Re: Submission Review: 60th Avenue at Box Elder – Infrastructure Site Plan
Application Number: DA-1478-14
Case Numbers: 2024-6039-00

THIRD SUBMISSION REVIEW

BOX ELDER INFRASTRUCTURE SITE PLAN

OVERALL
PLAN

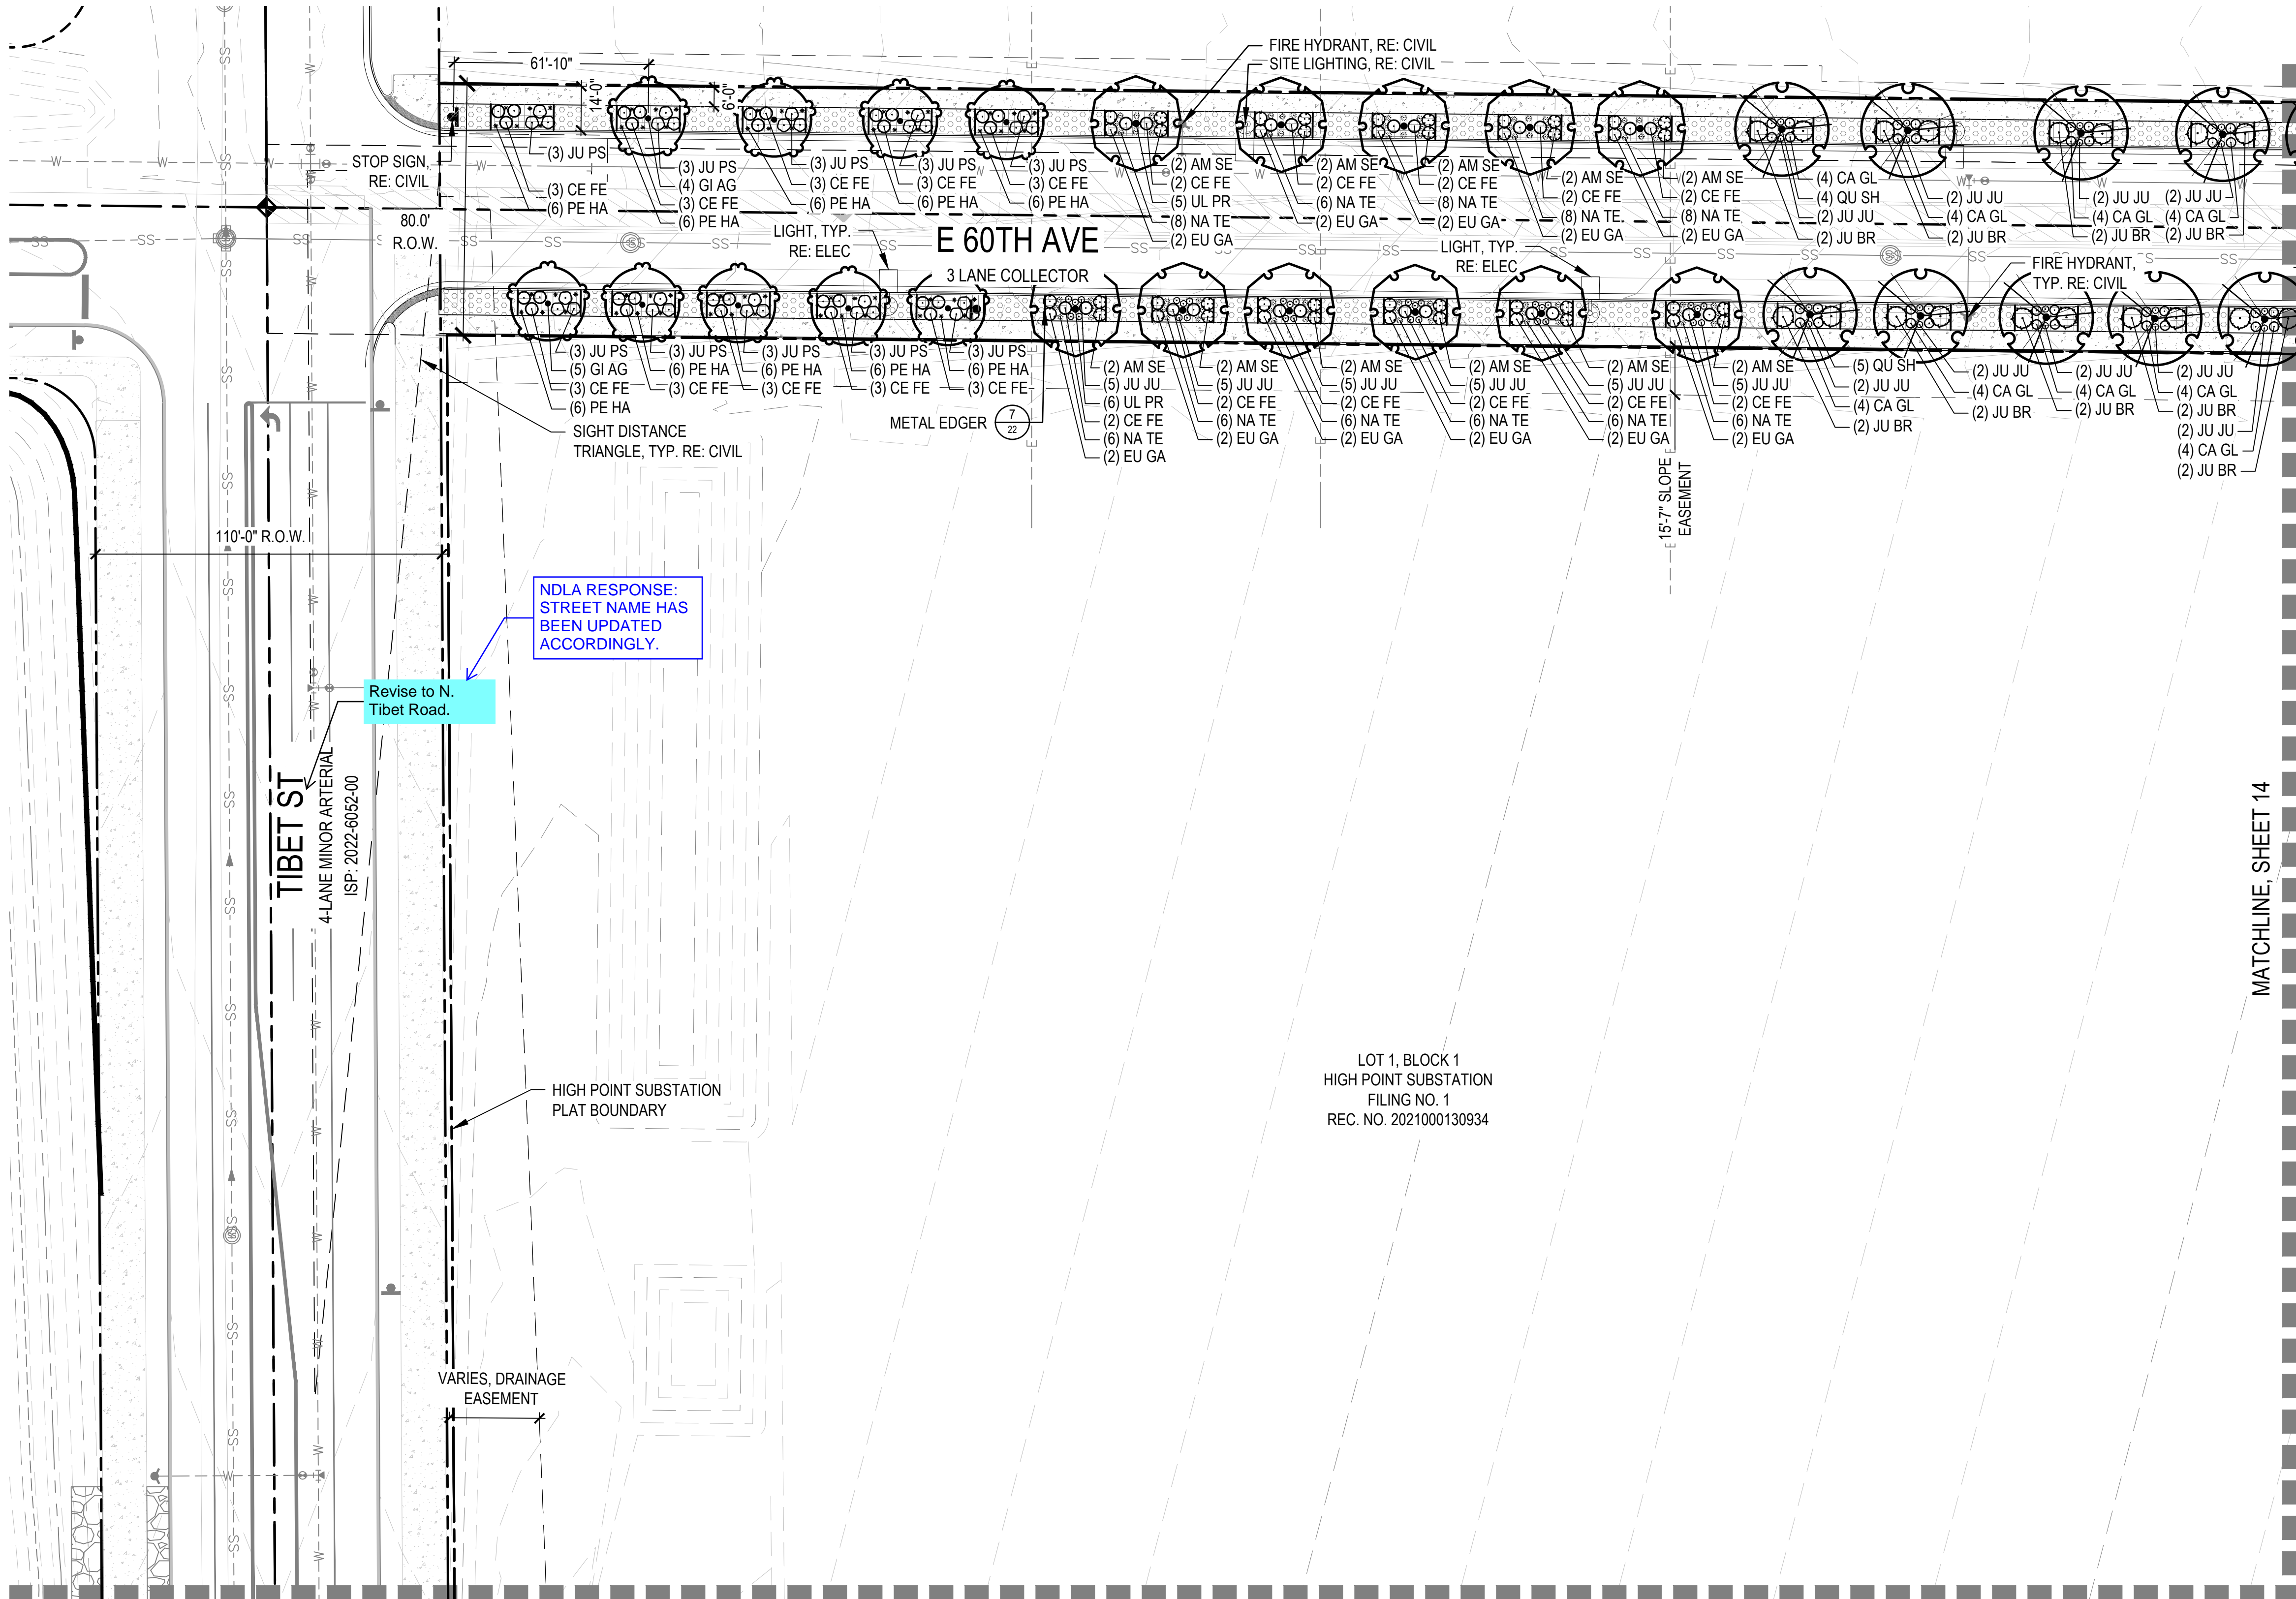
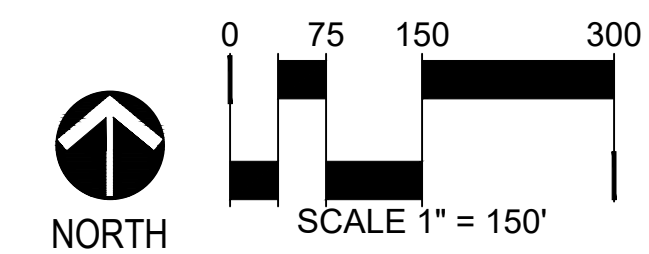
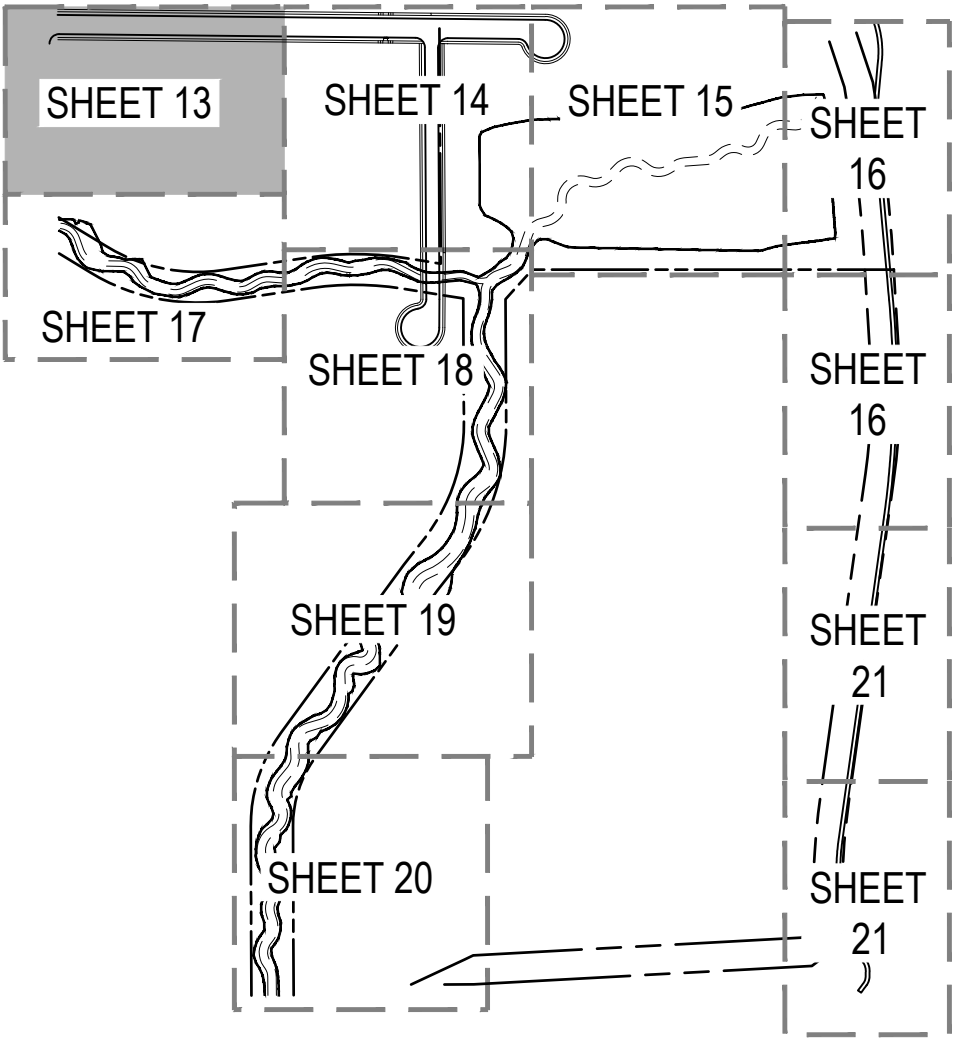
2L. Sheet 12: Revise to N. Tibet Road.

Response: Street name has been revised accordingly.

LANDSCAPE
PLAN

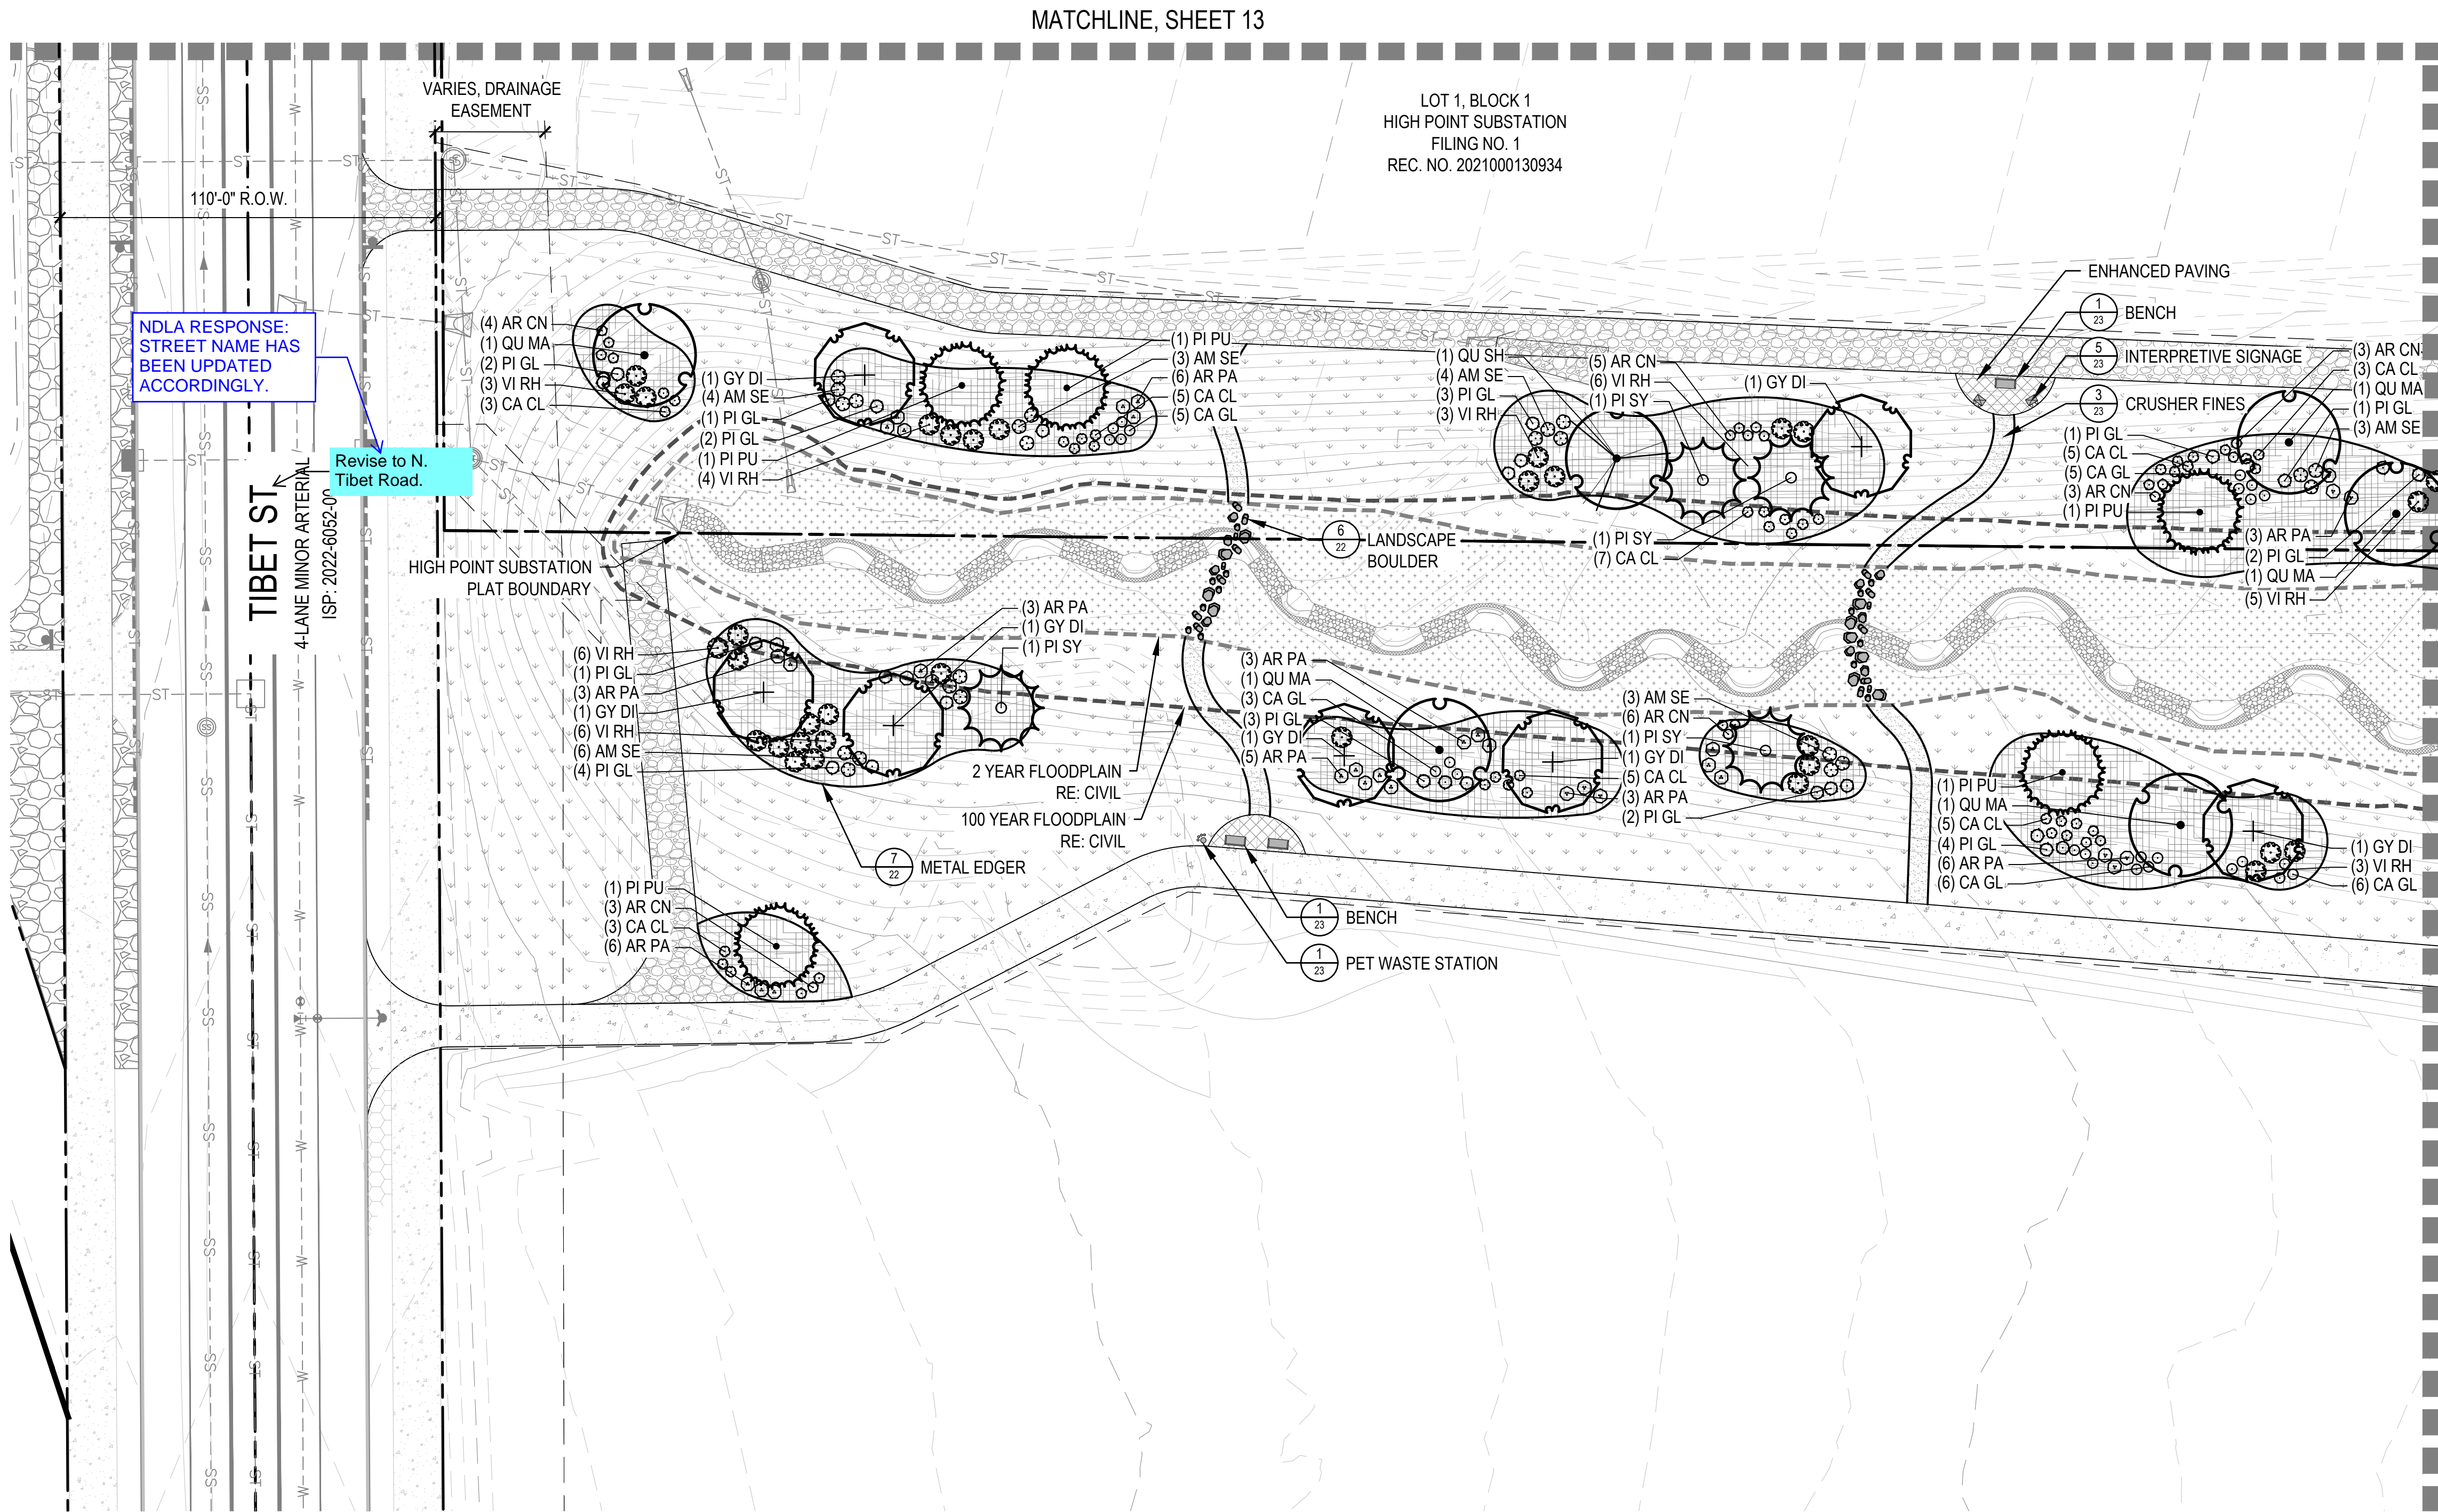
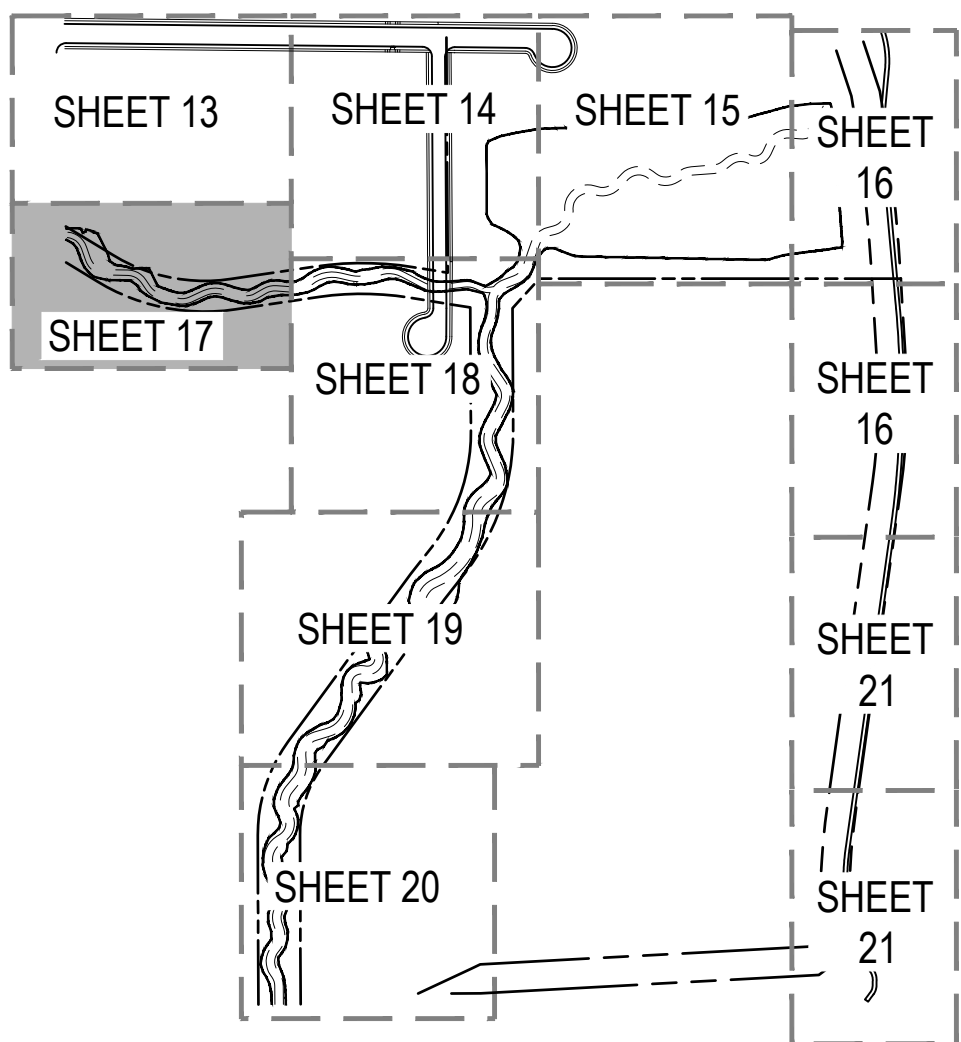
2M. Sheet 13: Revise to N. Tibet Road.

Response: Street name has been revised accordingly.
